**SUBJECT:** Comanche Peak Nuclear Power Plant, Docket Nos. 50-445 AND 50-446,  
Fourth Six-Month Status Report in Response to March 12, 2012, Commission Order  
Modifying Licenses with Regard to Requirements For Mitigation Strategies For Beyond-  
Design-Basis External Events (Order Number EA-12-049) (TAC NOS. MF0860 and  
MF0861)

**Comanche Peak Nuclear Power Plant's (CPNPP) Fourth Six Month Status Report  
for the Implementation of Order EA-12-049, Order Modifying Licenses with Regard to  
Requirements for Mitigation Strategies for Beyond-Design-Basis External Events**

Figure A3-23: Phase 2 480VAC FLEX Generator Connection to Plant Support Power  
103

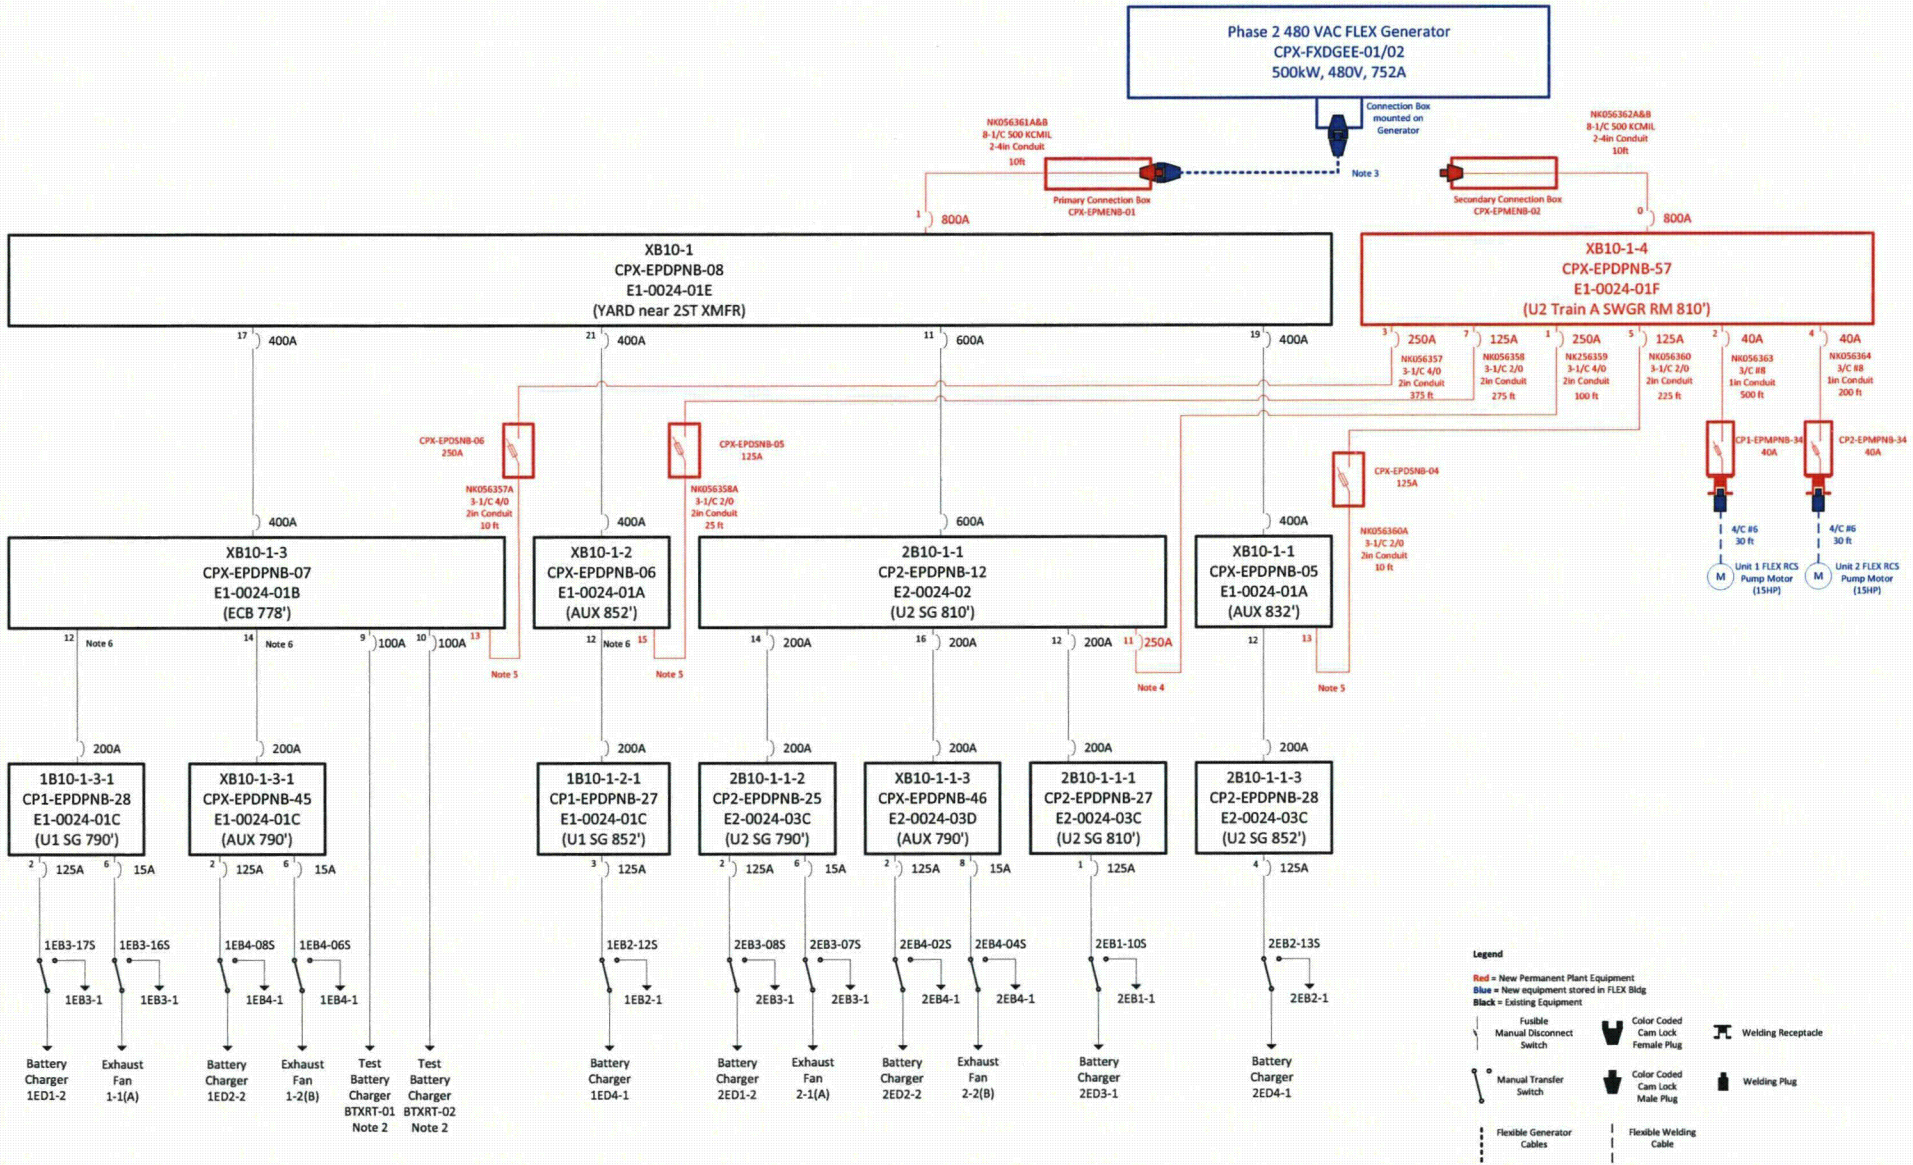
Further review of Figures A3-23 through A3-29 of the OIP concludes improvement in understanding of the associated Phase 2 FLEX strategy can be achieved by figure consolidation. This is not a change in compliance method but merely an improvement in the depiction of the Phase 2 480VAC generator and its physical connection to the credited Phase 2 loads through Plant Support Power. Figure A3-23 of the OIP should be replaced with that provided in Appendix A of this letter and Figures A3-24 through A3-29 of the OIP should be deleted. All text references in the OIP to Figures A3-24 through A3-29 should reference Figure A3-23 solely.
